B 9489
FLEXIBLE DISK DRIVE

TECHNICAL
MANUAL

PUBLICATION
CHANGE
NOTICE

PCN No.: 2102141-002 Date: January 1980
Publication Title: B 9489 Flexible Disk Drive Technical Manual
Other Affected Publications: None
Supersedes: None

FIGURE 2.

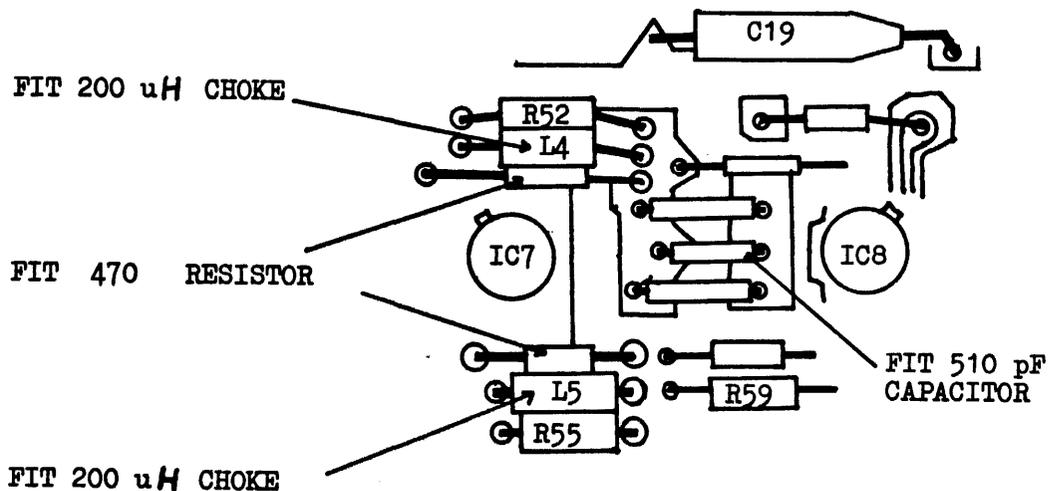
3. Remove the following components.
R53, R54, R154, R155, TP16, TP17, C17, C13.
Retain C13 (510pF) for future use.
4. Fit two 470 Ω resistors (P/N 1876 5008) as shown in Figure 2.
5. Fit two 200 μ H Chokes (P/N 1103 0046) as shown in Figure 2.
6. Fit the 510pF Capacitor (removed in Step 3) in the C17 position.

FIGURE 4.

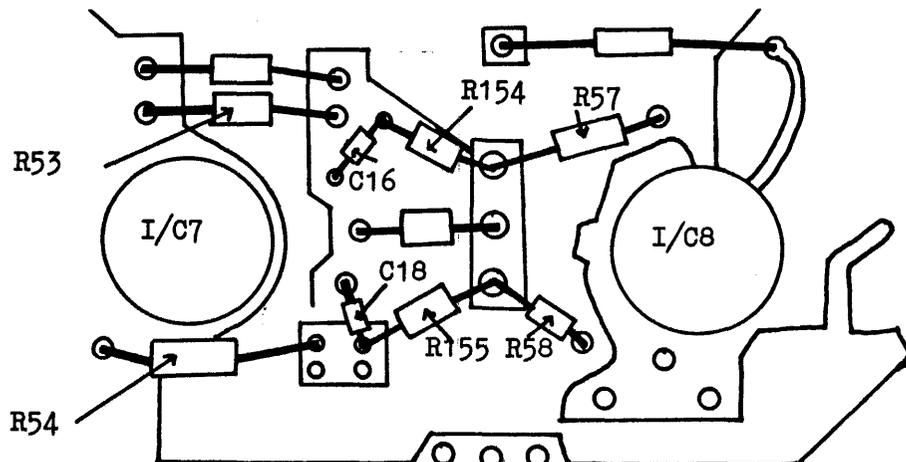
9. Remove R53, R54, R57, R58, R154, R155, C13, C16, C17 C18 as shown in figure 4.
Retain C13 (510pF) for future use.

FIGURE 6.

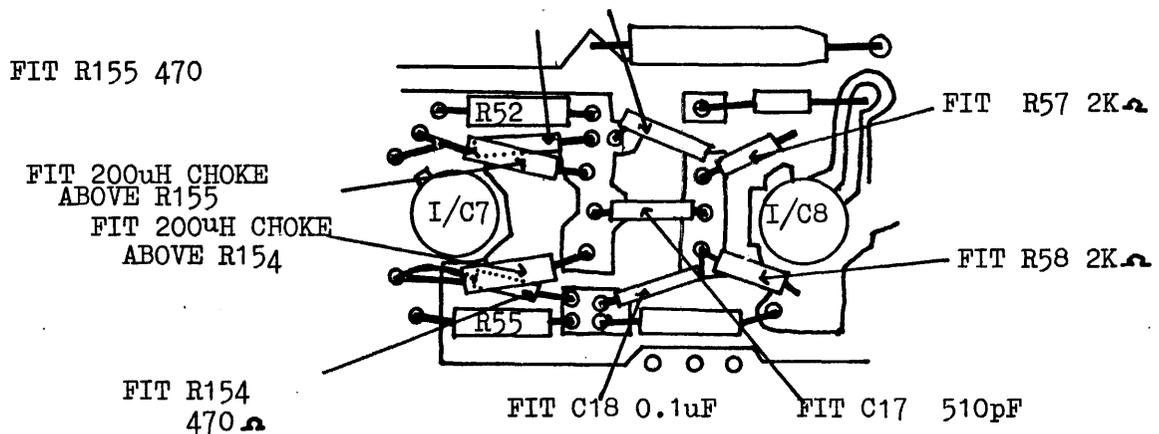
13. Fit two $470\ \Omega$ resistors P/N 1876 5008 in the R53, R54 positions as shown in Figure 6.
14. Fit the two test points (TP16, TP17) in the right hand holes of the C16 and C18 positions (The holes nearest to I/C8)
These test points will now be called the C16 and C18 pins.
15. Fit a $2K\ \Omega$ resistor (R57 removed in Step 11) between R57 right-hand hole (hole nearest to I/C8) and the C16 pin.
16. Fit a $2K\ \Omega$ resistor (R58 removed in Step 11) between R58 right-hand hole (hole nearest to I/C8 and the C18 Pin).

FIGURE 3

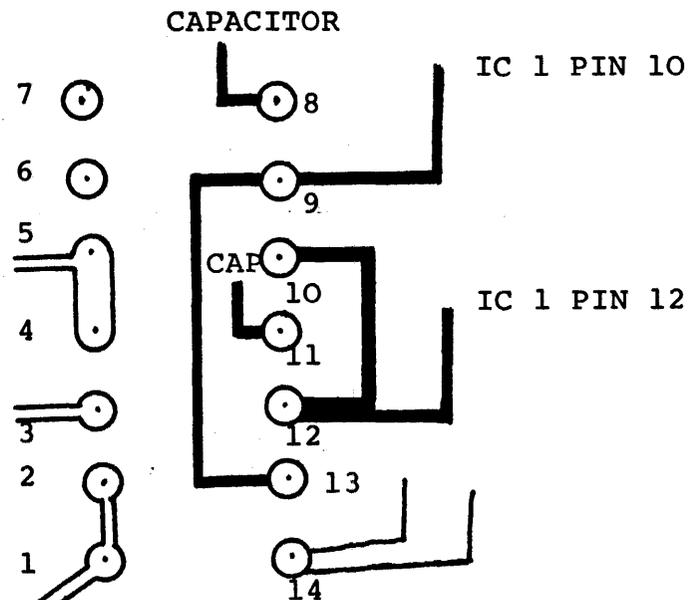
4. Refer to Figures 1 and 2. Install a 220OpF Capacitor (P/N 1877 1287) vertically into the hole vacated by R57 in step 2.
5. Connect the other lead of the 2200 pF capacitor to the lead of C16.
6. Install a 2200 pF capacitor (P/N 1877 1287) vertically into the hole vacated by R58 in Step 3.
7. Connect the other lead of the 220OpF Capacitor to the lead of C18.
8. Install the following jumpers.
 - IC1 Pin 12 to IC20 Pin 12.
 - IC1 Pin 10 to IC20 Pin 9.
9. Install the following jumpers
 - IC20 pin 10 to IC20 Pin 12 (Refer to Figure 3)
 - IC20 pin 9 to IC20 Pin 13

10. Install the following jumpers (Refer to figures 1, 2 and 3) IC20 Pin 8 to the PCB end of the Capacitor installed in steps 4.

FIGURE 4

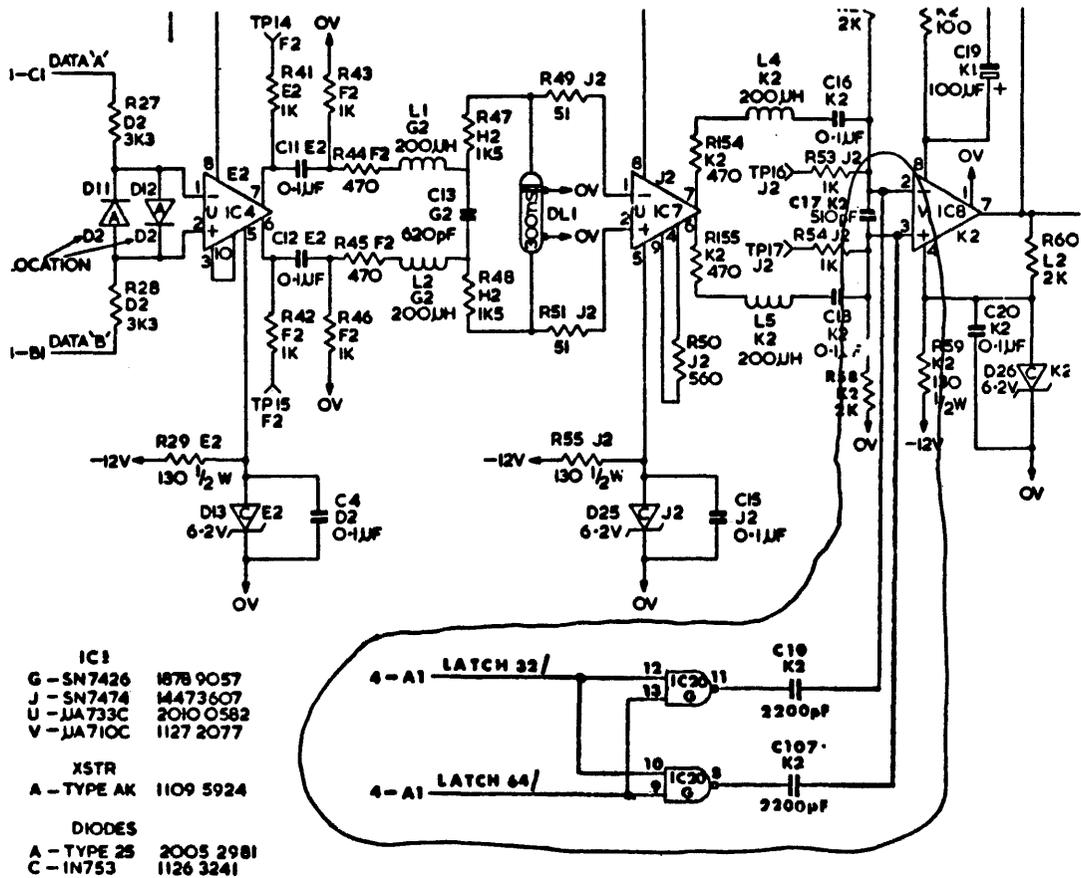
11. Modify the schematics as shown in figures 4 and 5.

FIGURE 3

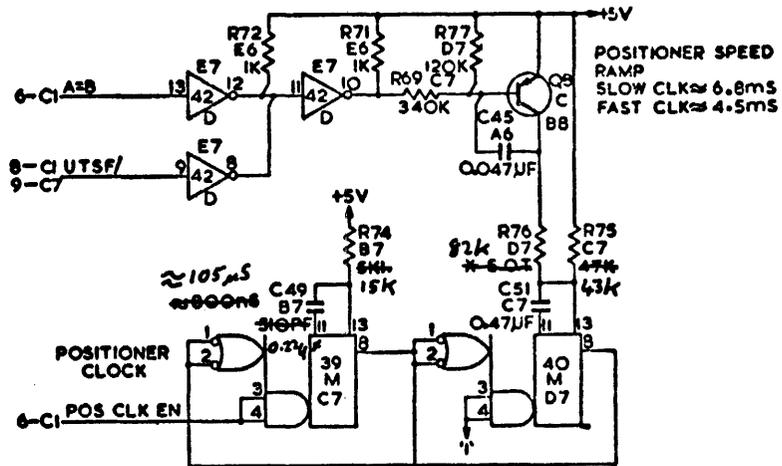
4. Replace C49 by a $0.22\ \mu\text{F}$ capacitor (P/N 1876 9919)
5. Replace R74 by a $15\text{K}\Omega$ resistor (P/N 1876 5362)
6. Replace R75 by a $43\text{K}\Omega$ resistor (P/N 1876 5479)
7. Replace R76 by a $82\ \text{K}\Omega$ resistor (P/N 1876 5545)
8. Update the schematic as shown in figure 3.

FIGURE 7.

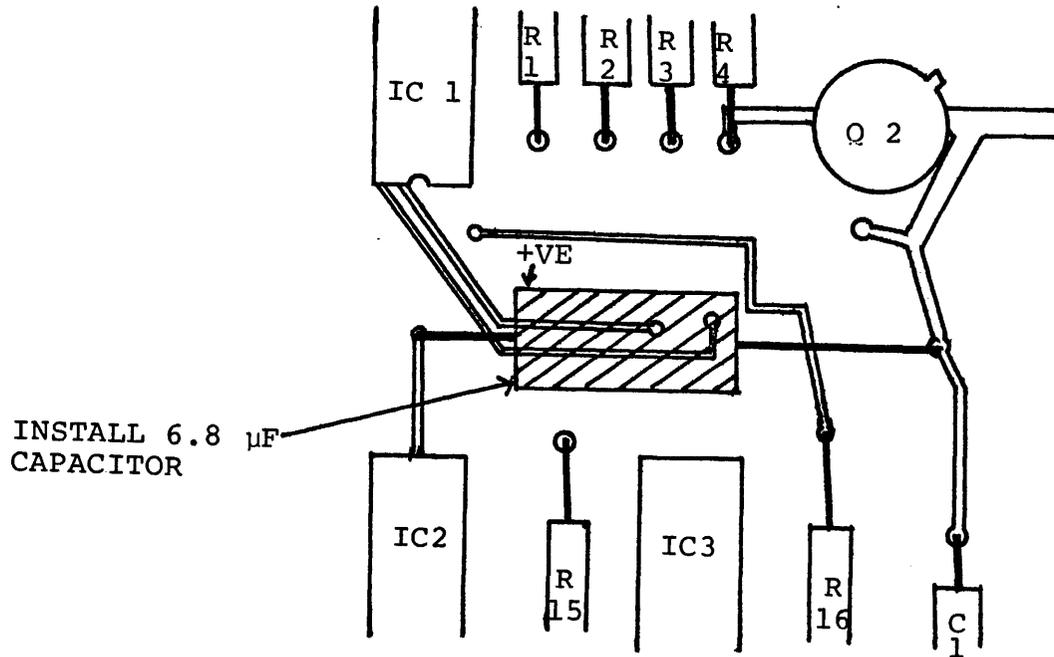
16. Install a 6.8μF capacitor (P/N 1877 0578) on the component side of the PCB at Location A2 as shown in figure 7.

FIGURE 8

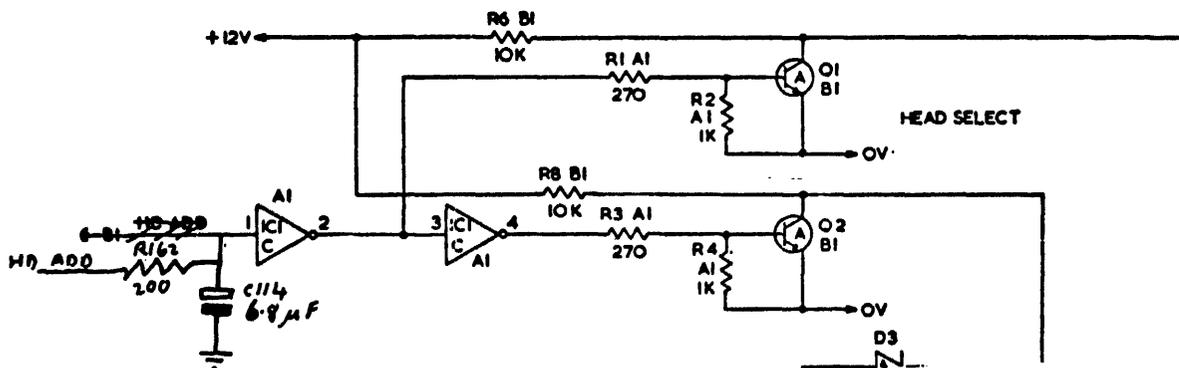
NOTE: Observe polarity of the Capacitor.
17. Update the schematics as shown in figure 8.

FIGURE 1 COMPONENT SIDE REWORK

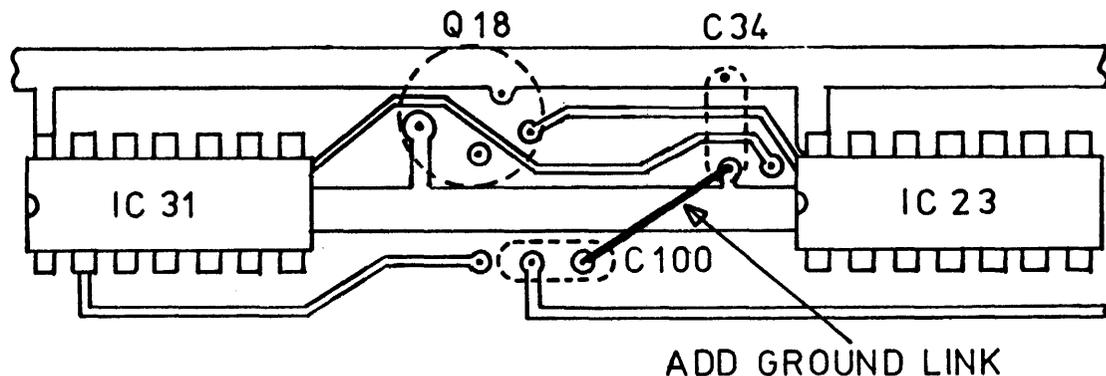
- 1) Remove the slave unit from the B-80.
- 2) On component side, location C5, add a jumper wire between the end of C100 nearest IC 23 and the ground at C34. (Refer Figure 1)
- 3) Replace drive in the B-80 and run an operational check.

FIGURE 1: READ ENABLE DELAY (150 μs)

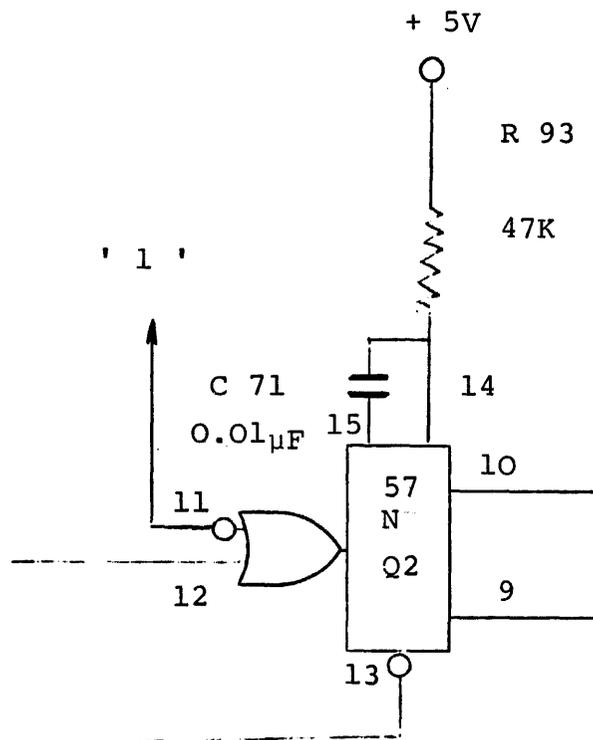
4. Replace resistor R 93 at location 2Q with a 47K ohm resistor.
5. Refit the master board to the drive unit.
6. Refit the disk drive unit to the Host System.
7. Switch on the power to the Host System.
8. Carry out an operational check of the System.
9. Amend the schematics to reflect the change.

FIGURE 1: INDEX/SECTOR 1 μs PULSE GENERATOR.

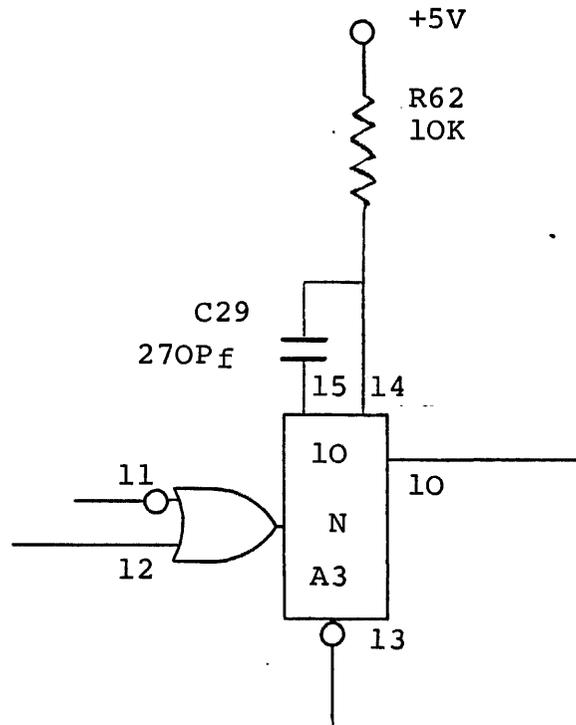
1. Switch off the power to the Host System.
2. Remove the disk drive unit from the Host System.
3. Remove the P.C.B. from the drive unit.
4. Replace resistor R62 at location A4 with a 10K ohm resistor.
5. Refit the P.C.B. to the drive unit.
6. Refit the disk drive unit to the Host System.
7. Switch on the power to the Host System.
8. Carry out an operational check of the System.
9. Amend the schematics to reflect the change.
